Access Compliance Report

Public Rights-of-Way

(Curb Ramps)

Intersection ID: 24872	Main Street: CARMEL_RD	Cross Street: GLEN_FOREST_DR	Location: NW
ADA ID: F8073C0E56AA	Ramp Type: PerpDiag	Initial Pass/Fail: Fail	Overall Compliance: No
		Severity Score: 22.5

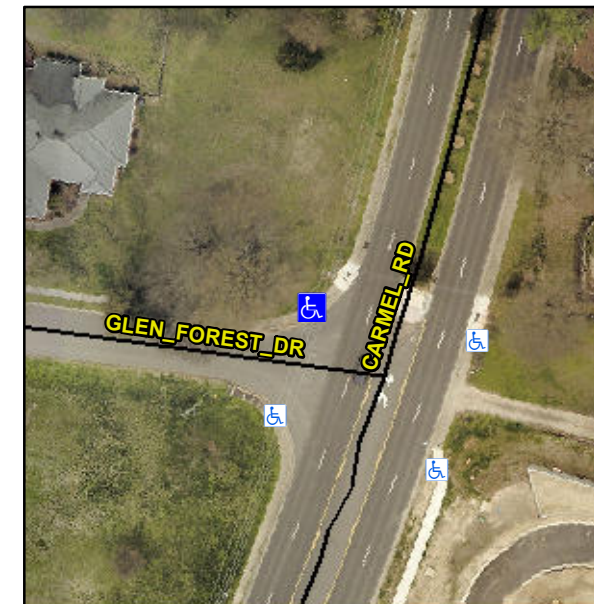
Not Found, R304.5.1, R304.2.2, R304.5.3

Compliance	Description	Data	Compliance	Description	Data
N/A	Ramp Length (in)	60.0	No	Ramp Slope (%)	8.6
No	Ramp Width (in)	46.0	No	Ramp XSlope (%)	2.3
N/A	Flare Type LT	N/A	N/A	Flare Type RT	N/A
N/A	Flare Slope LT (%)	N/A	N/A	Flare Slope RT (%)	N/A
N/A	Flare Traversable LT?	N/A	N/A	Flare Traversable RT?	N/A
N/A	Landing Length (in)	N/A	N/A	DWS Provided?	N/A
N/A	Landing Width (in)	N/A	N/A	DWS Contrast?	N/A
N/A	Landing Slope (%)	N/A	N/A	DWS Length (in)	N/A
N/A	Landing X Slope (%)	N/A	N/A	DWS Full Width?	N/A
N/A	Landing Curb? (Y/N)	N/A	N/A	DWS Offset (in)	N/A
N/A	Shared Landing?	N/A			
N/A	Gutter Ponding?	N/A	N/A	Gutter Slope (%)	N/A
N/A	Gutter Lip Ht (in)	N/A	N/A	Gutter X Slope (%)	N/A
N/A	Painted X Walk1?	No	N/A	Painted X Walk2?	No
	X Walk 1 Direction	To SW		X Walk 2 Direction	To SE
N/A	X Walk 1 Width (in)	N/A	N/A	X Walk 2 Width (in)	N/A
	X Walk 1 Slope (%)	1.8		X Walk 2 Slope (%)	2.2
	X Walk 1 X Slope (%)	2.1		X Walk 2 X Slope (%)	2.6

Remove & Replace Curb Ramp With Two New Directional Ramps or Equivalent.
